Product Change Notification / ASER-15CAKZ286

CCB 4630.001 Final Notice: Qualification of STA as an additional assembly site for selected CAP1188, USB33xx and USX2030 device families available in 24L VQFN (4x4x0.9mm) package.

CCB 4630.001
Pre and Post Change Summary
PCN #: ASER-15CAKZ286

QUALIFICATION REPORT SUMMARY
RELIABILITY LABORATORY

Lead frame Comparison

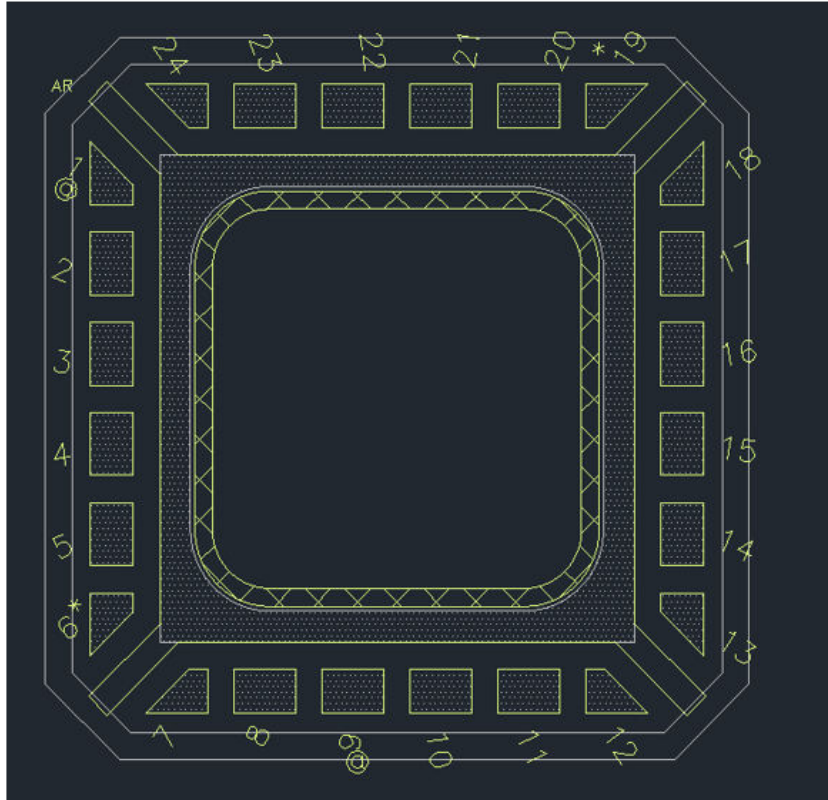
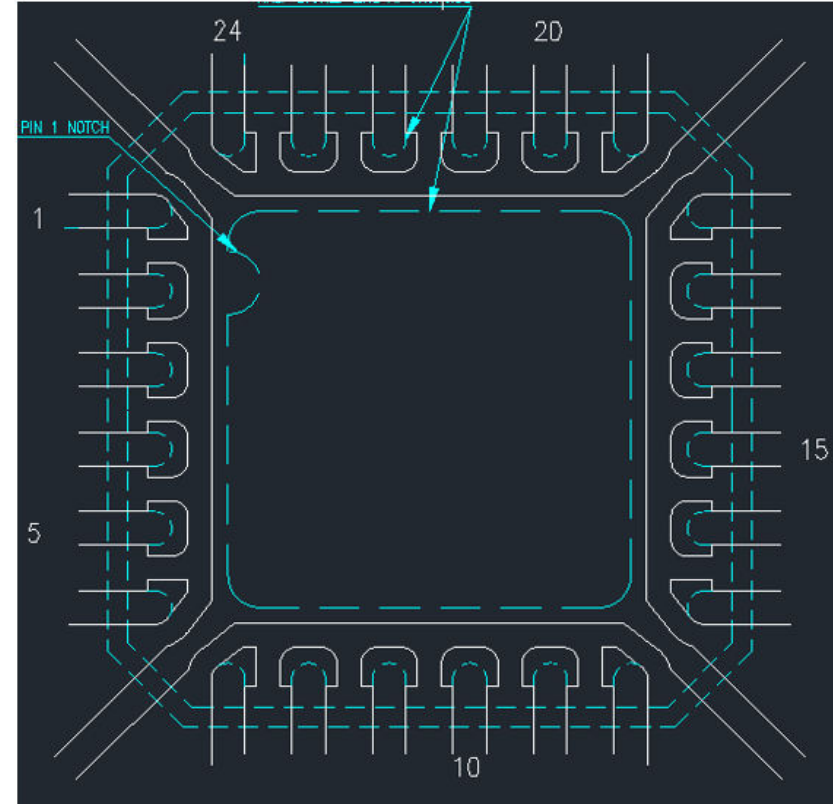
Assembly Site		ASE Inc. (ASE)		ASE Inc. (ASE)		STATS Chippac Ltd. (STA)
Wire Material		PdCu	Au	PdCu	Au	CuPdAu
Die Attach Material		EN-4900F		EN-4900F		8290
Molding Compound Material		G631B		G631B		G700E
Lead Frame	Material	C194		C194		C194
	Design	See Pre and Post Change Summary for comparison.
